# **Preliminary Chelan River Use Attainability Analysis and Site Specific Criteria**

## **Technical Support Document**

March 2021, Publication 21-10-008

On December 20, 2019, the Department of Ecology (Ecology) received a request from the Public Utility District No. 1 of Chelan County (Chelan PUD) to modify the aquatic life designated use in the Chelan River. To support a change to the state surface water quality standards, Chelan PUD submitted a use attainability analysis (UAA) and proposed site-specific criteria (SSC) that would reflect the highest attainable aquatic life use. After determining that the UAA submittal met the requirements in Chapter 173-201A-440 to consider a change to the designated use, Ecology responded on February 18, 2020 indicating that Chelan PUD's request was sufficient to consider rulemaking. Ecology formally announced the start of the Chelan River UAA rulemaking on October 27, 2020. Since rulemaking commenced, Ecology staff have reviewed the information and analyses in the proposed UAA and SSC to determine if changes to Chelan PUD's submittal are necessary.

Figure 23 Comparison of simulated probabilities of two or more non-overlapping exceedances and one or more Exceedances for Reaches 1-3 (adapted from Mugunthan et al. 2019).

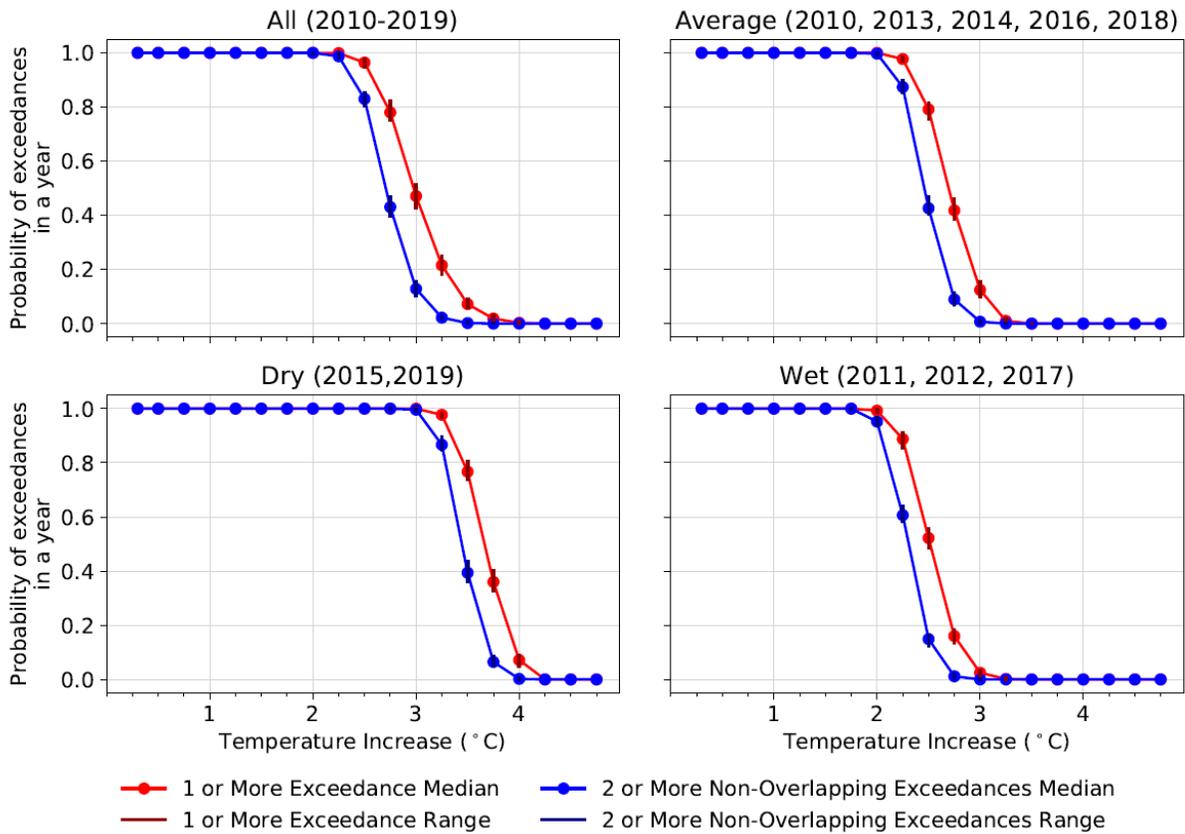
end of Reach 3. Chelan PUD proposed a temperature increase from the LLO to the end of Reach 3 of 3.6°C. The Chelan PUD proposed 7-DADMax temperature increase of 3.6°C coupled with a duration of two or more non-overlapping 7-DADMax increased is predicted never to occur in the future based on statistical analyses.

We are suggesting revisions to Chelan PUD's proposal for site-specific temperature criteria in Reaches 1-3. Rather than using a modified definition of an exceedance (two or more non-overlapping 7-DADMax increases), we propose to use the standard definition of an exceedance, where one or more values greater than the 7-DADMax increase is considered out of compliance. The standard definition of an exceedance aligns with current methods for determining compliance for temperature in all state waters. The use of two or more non-overlapping exceedances, as proposed by Chelan PUD, provides significantly more leniency and is based upon our Policy 1-11 listing methodology for impaired waters. The implementation of the water quality standards differs from the methodology for determining an impaired water. We contend that it is not necessary to modify the definition of an exceedance as it may result in difficulties in interpretation and that modification to the magnitude of the criteria is the more appropriate pathway forward.

Chelan PUD has proposed a maximum allowable increase in the 7-DADMax of 3.6°C for Reaches 1-3. Chelan PUD's proposal of an allowable temperature increase of 3.6°C coupled with defining an exceedance as two or more non-overlapping 7-DADMax temperature increases is predicted to never result in a future exceedance based on statistical analyses. This proposal is not adequately stringent when considering the frequency component to temperature criteria, monitoring data, and statistical analyses. Washington's statewide temperature criteria has an allowable exceedance frequency of no more than once every 10 years on average, that in turn, provides flexibility and allows for an occasional exceedance during extreme climatic years. Using the standard definition of an exceedance, statistical analyses conducted by Chelan PUD suggests that an allowable 7-DADMax temperature increase of 3.75°C would be exceeded once every 50 years. While this may not align with the temperature criteria frequency of no more than one exceedance every 10 years, monitoring data from 2010-2018 has demonstrated warming up to 3.5°C on dry years (Figure 9). Considering nine years of data is not representative of climatic variation for all foreseeable years, and climate change will likely result in increased warming, we have proposed an allowable 7-DADMax temperature increase of 3.75°C, using the standard definition of an exceedance. While the 3.75°C 7-DADMax temperature increase represents a higher magnitude than the proposed value of 3.6°C by Chelan PUD, the overall proposed SSC is more stringent because of the decision to use the standard definition of an exceedance.

Figure 24 Comparison of simulated probabilities of two or more non-overlapping exceedances and one or more exceedance for the Reach 4 habitat channel (adapted from Mugunthan et al. 2019).

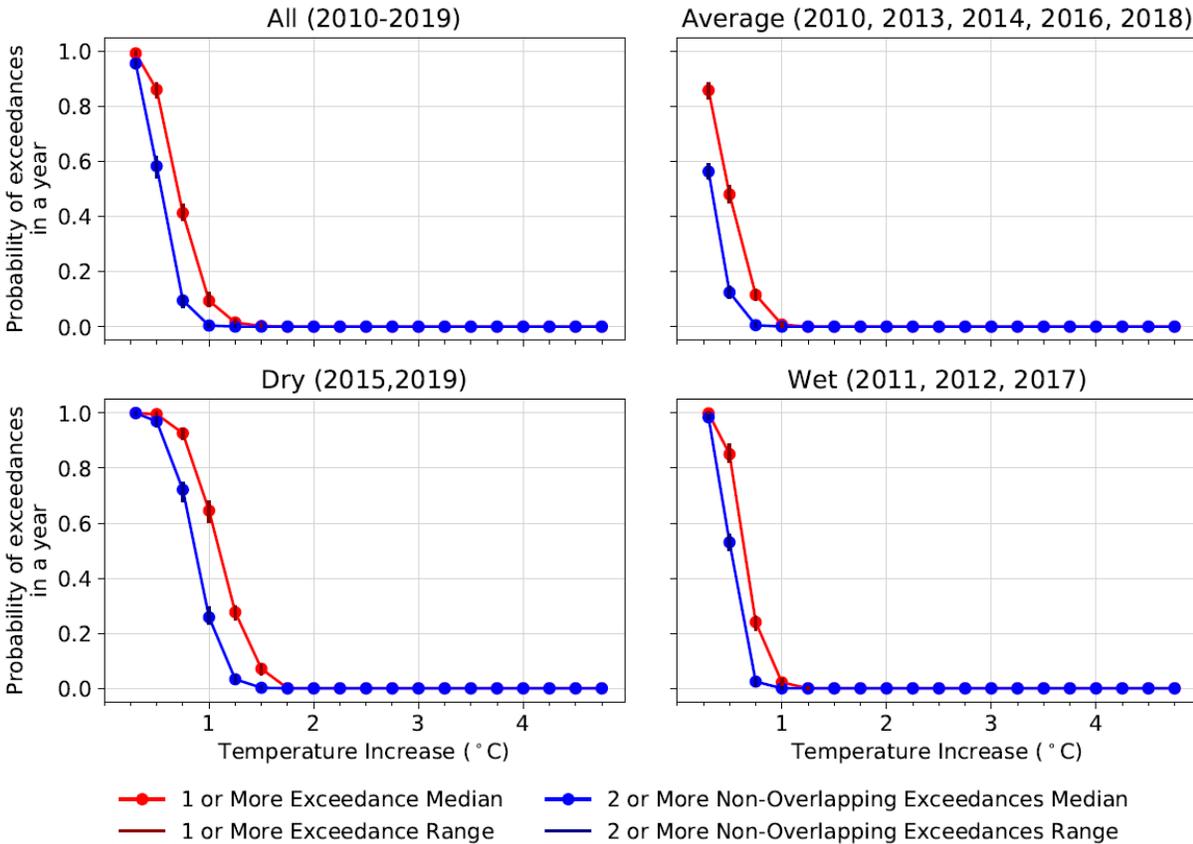
We are proposing revisions to Chelan PUD's proposal for site-specific temperature criteria in Reach 4. Rather than using a modified definition of an exceedance (two or more non-overlapping 7-DADMax increases), we propose to use the standard method of an exceedance, where one or more values greater than the 7-DADMax increase is considered out of compliance. The standard definition of an exceedance aligns with current methods for determining compliance for temperature in all state waters. The use of two or more non-overlapping exceedances, as proposed by Chelan PUD, provides significantly more leniency and is based upon our Policy 1-11 listing methodology for impaired waters. The implementation of the water quality standards differs from the methodology for determining an impaired water. We contend that it is not necessary to modify the definition of an exceedance as it may result in difficulties in interpretation and that modification to the magnitude of the criteria is the more appropriate pathway forward.

Chelan PUD, the overall proposed SSC is more stringent because of the decision to use the standard definition of an exceedance.
